LVP SWD 1

RKI Exploration and Production is requesting an increase in tubing injection pressure on the LVP SWD #1 (30-015-42234) well in Eddy County, New Mexico.

From:	Jay Brenner <jbrenner@rkixp.com></jbrenner@rkixp.com>
Sent:	Wednesday, November 19, 2014 3:12 PM
То:	Jody Noerdlinger, Paul Munding; Brent Umberham; Goetze, Phillip, EMNRD
Cc:	Charles Ahn; Heather Brehm; Cody Reid; Sam McCurdy; Jim Landrigan; Jim Auld
Subject:	RE: LVP SWD 1 injection pressure increase
Attachments:	LVP SWD 1 WBD 11-19-14.pdf

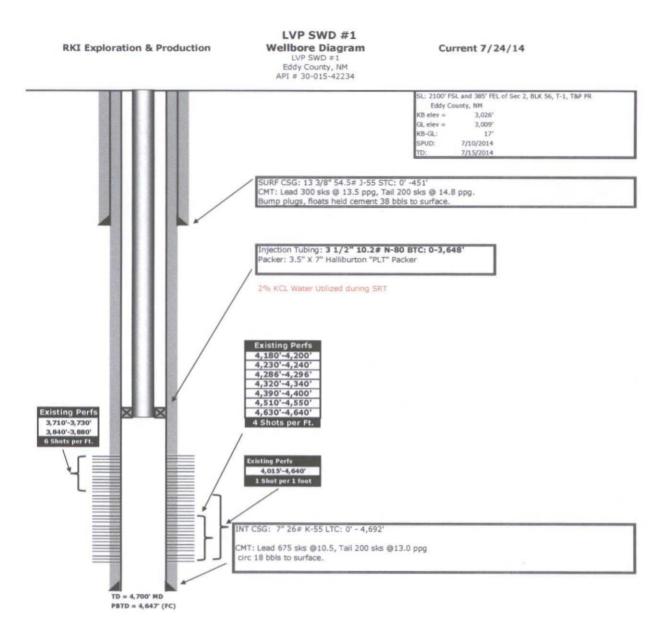
The application is being considered, but additional information would be of assistance. I am assuming that the SRT was measured by surface pressure only (no BH gauge)? Was fresh water or produced water used for the SRT? The original well construction in the SWD order showed 4.5-inch diameter tubing and perforations from 3400 ft to 4650 ft. Is the current diagram showing 3.5-inch diameter tubing and perforations from 4025 ft to 4650 ft correct? This will be critical in calculating friction pressure for the plotting of the BH pressures as well as assessing the pressure gradient. If this information could be provided via e-mail, then the review can proceed. PRG

I wanted to say thanks for taking the time with me on the phone today and it was a pleasure speaking with you. Per our conversation I have attached an updated wellbore diagram for LVP SWD #1 which includes and additional perf details and injection fluid type.

- 1. I am assuming that the SRT was measured by surface pressure only (no BH gauge)? That is correct surface pressure only.
- 2. Was fresh water or produced water used for the SRT? 2% KCL
